STATE OF MAINE
DEPARTMENT OF TRANSPORTATION
16 STATE HOUSE STATION
AUGUSTA, MAINE 04333-0016

October 3, 2025
Subject: Large Culvert 47382
Replacement
State WIN: 026630.08
Location: **Dennysville**
Amendment No. 2

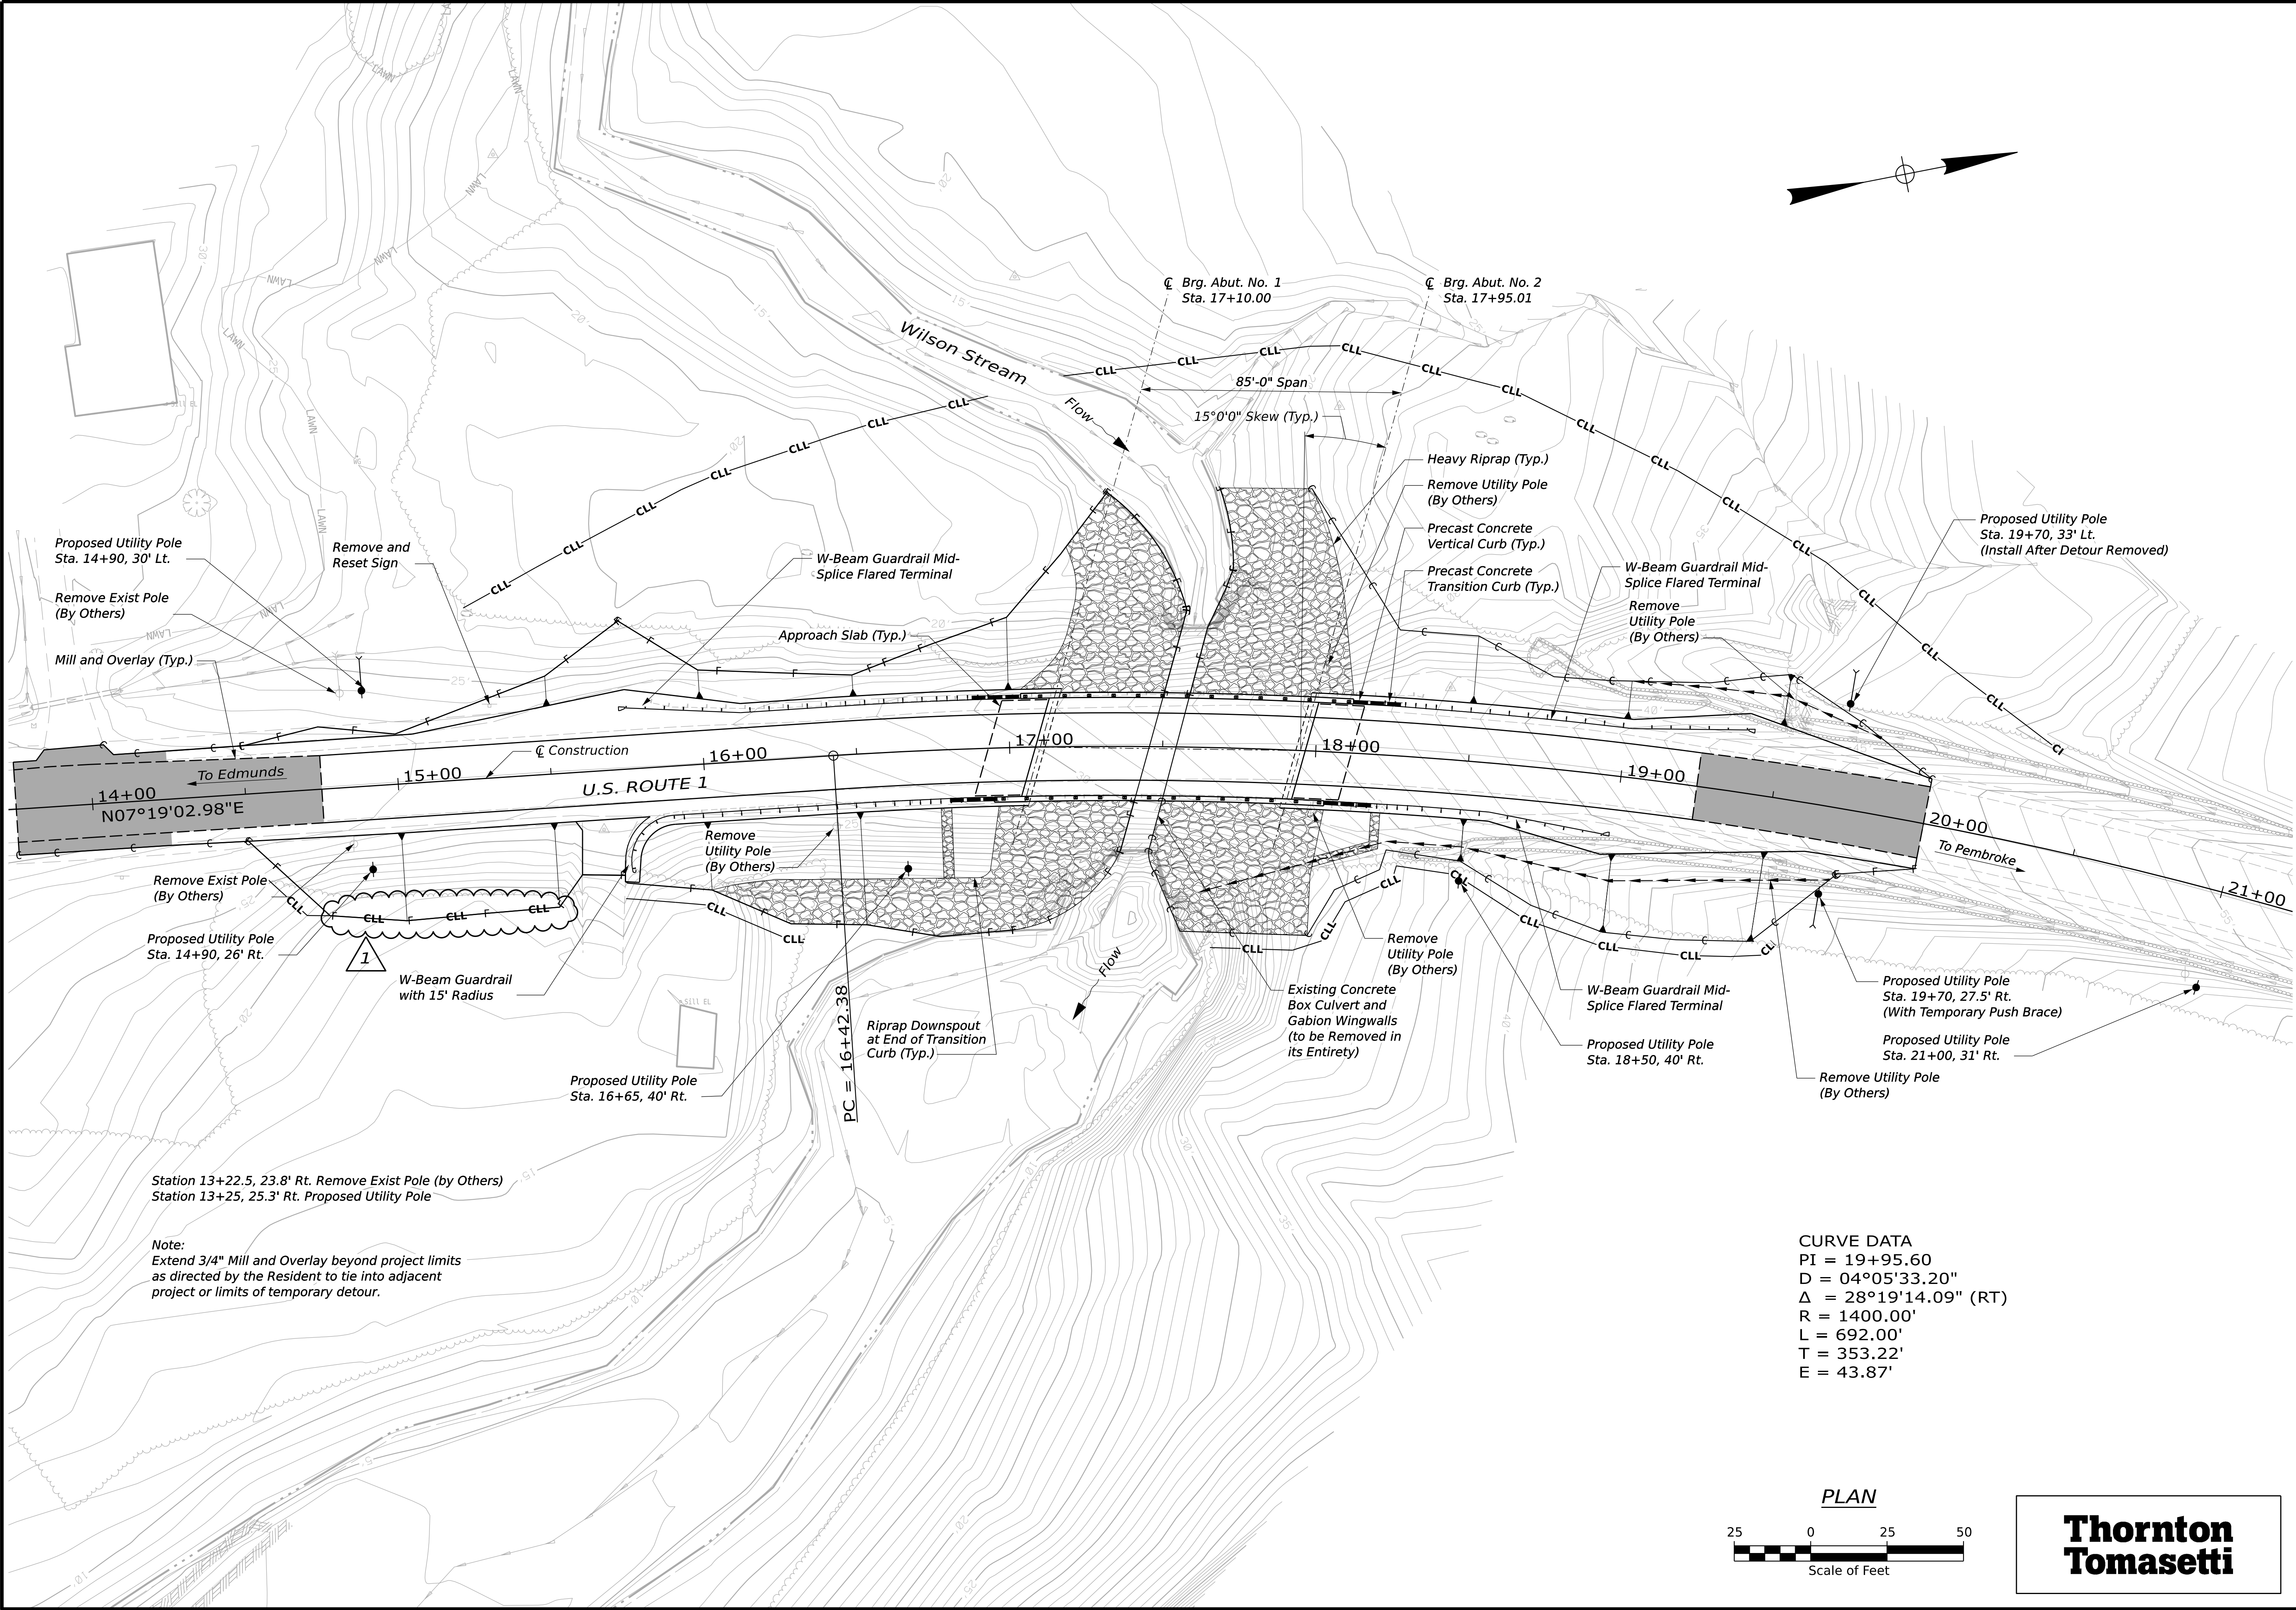
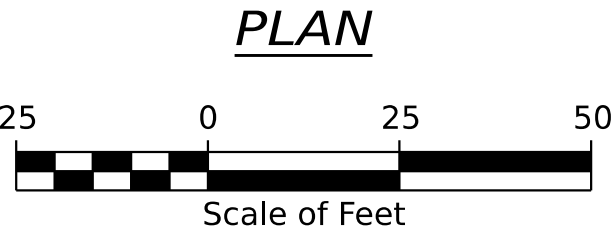
REMOVE Sheet 3 titled GENERAL PLAN dated 8/6/2025 and **REPLACE** with attached GENERAL PLAN dated 9/16/2025.

ROCK SOCKET DETAILS

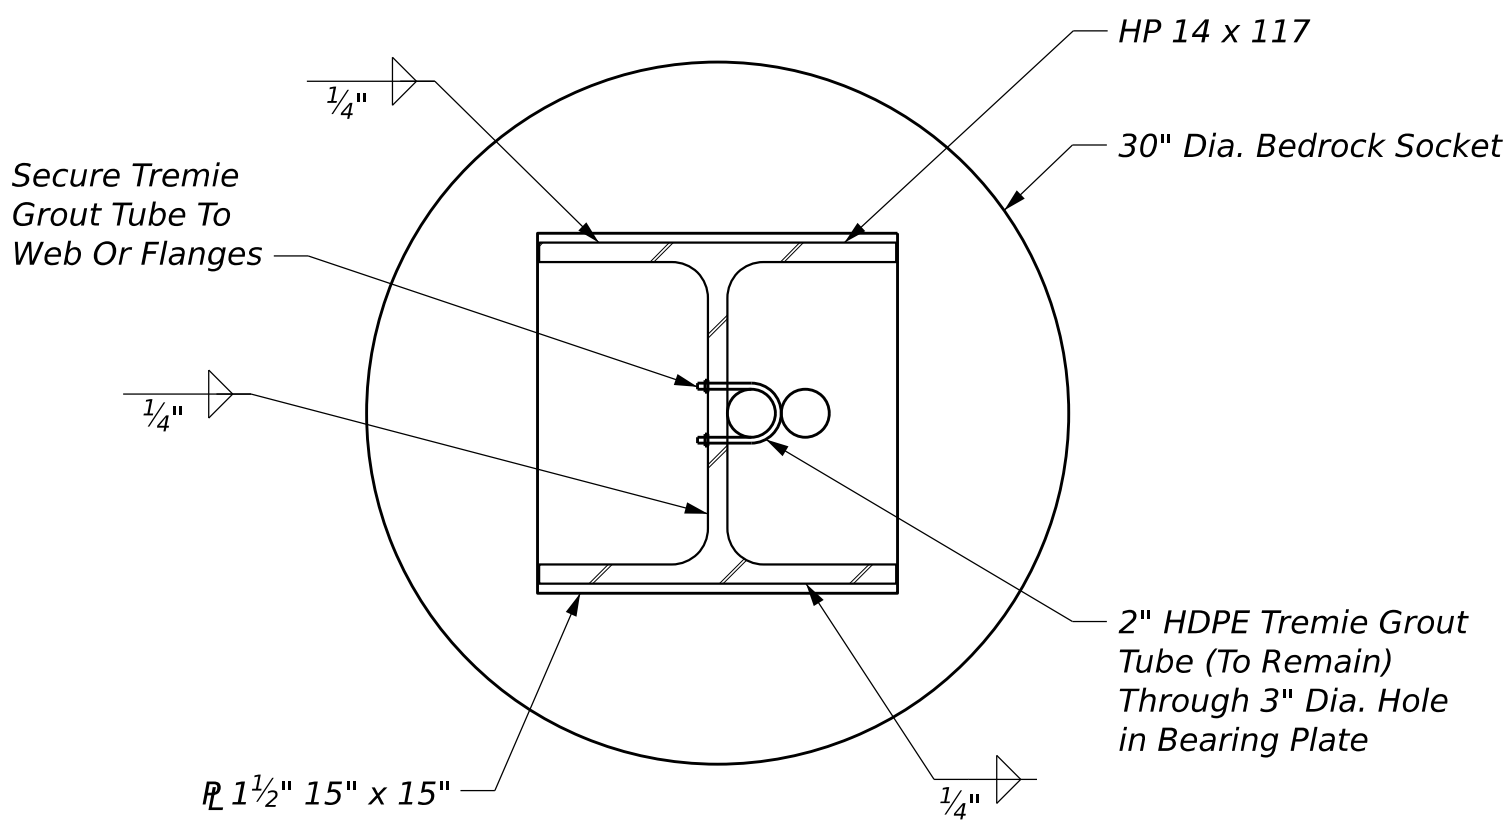
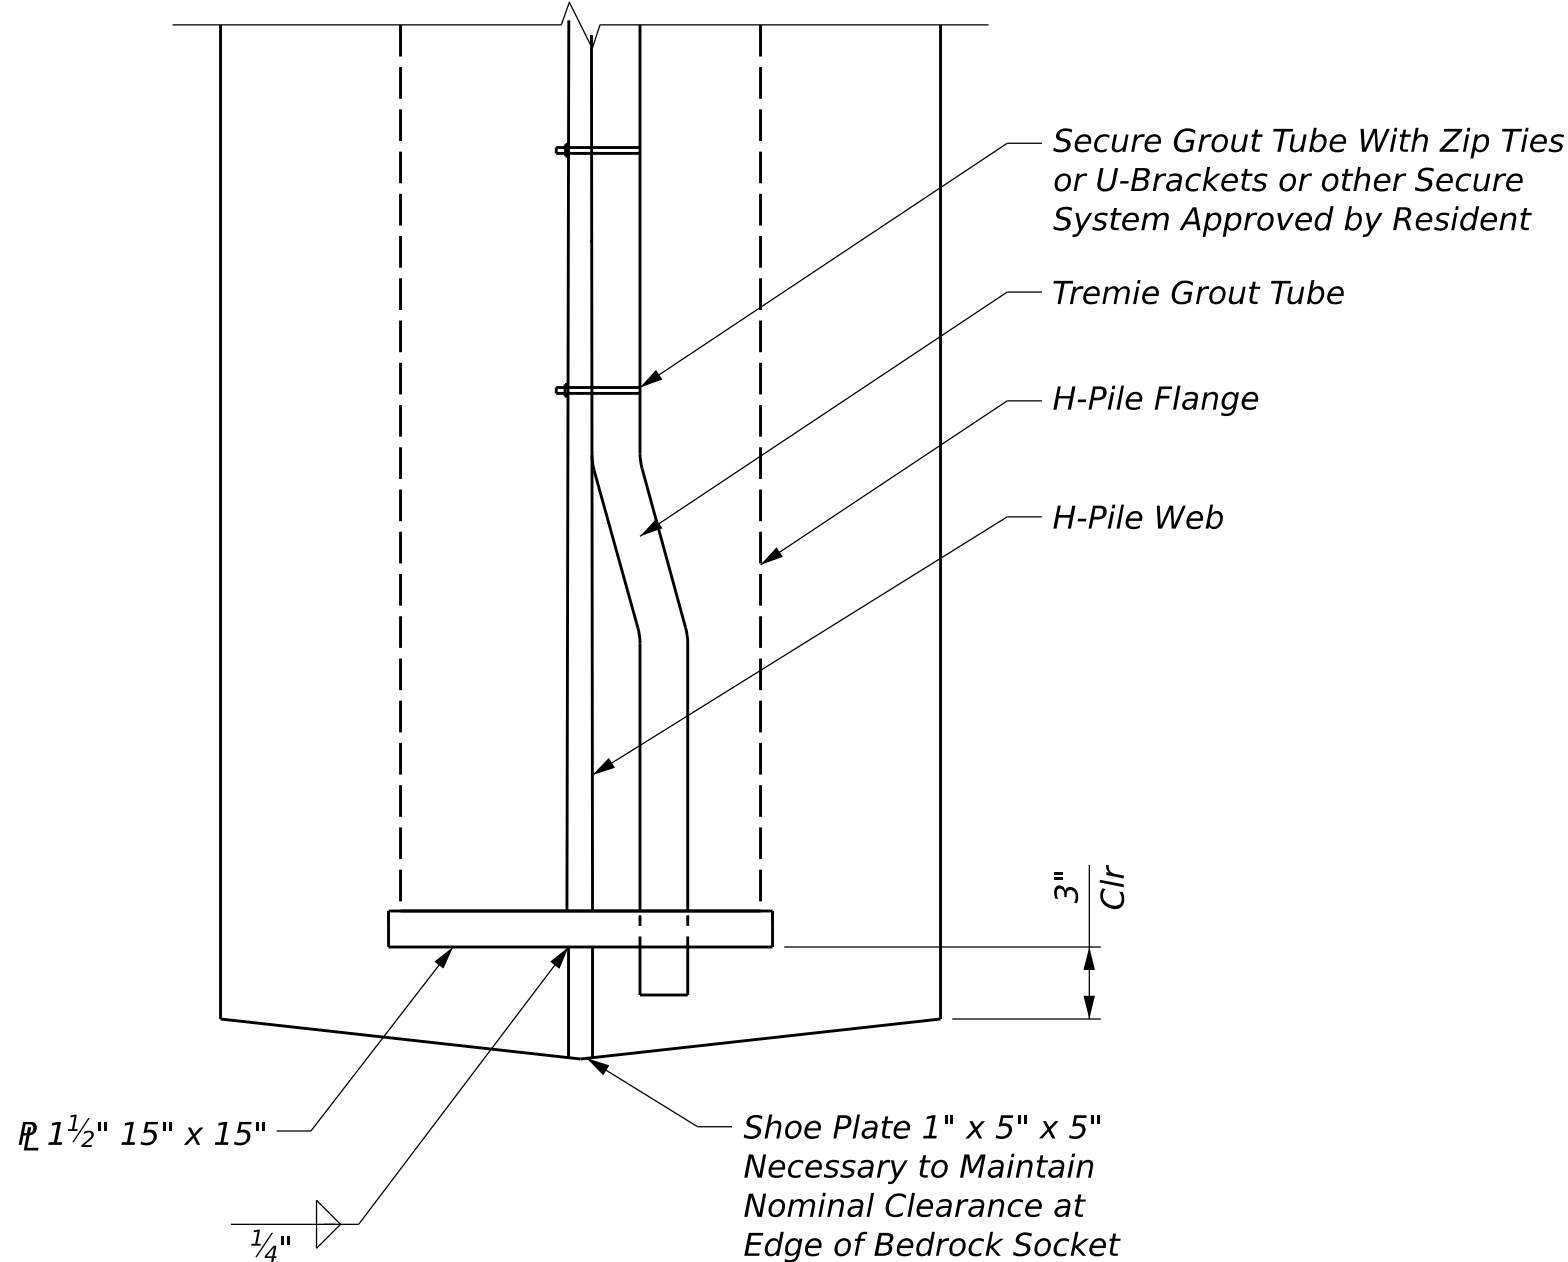
REMOVE Sheet 25 titled ROCK SOCKET DETAILS dated 8/6/25 and **REPLACE** with the attached Sheet 25 titled ROCK SOCKET DETAILS dated 9/16/25.

PROJ. MANAGER	MARK PARLIN	BY	DATE
DESIGN-DETAILED	EBROWNELL	EBURGESS	8/6/2025
CHECKED-REVIEWED	BWELCH	EBURGESS	8/6/2025
DESIGN-DETAILED			
DESIGN-DETAILED			
REVISIONS 1	Table and Notes Revised		9/16/2025
REVISIONS 2			
REVISIONS 3			
REVISIONS 4			
FIELD CHANGES
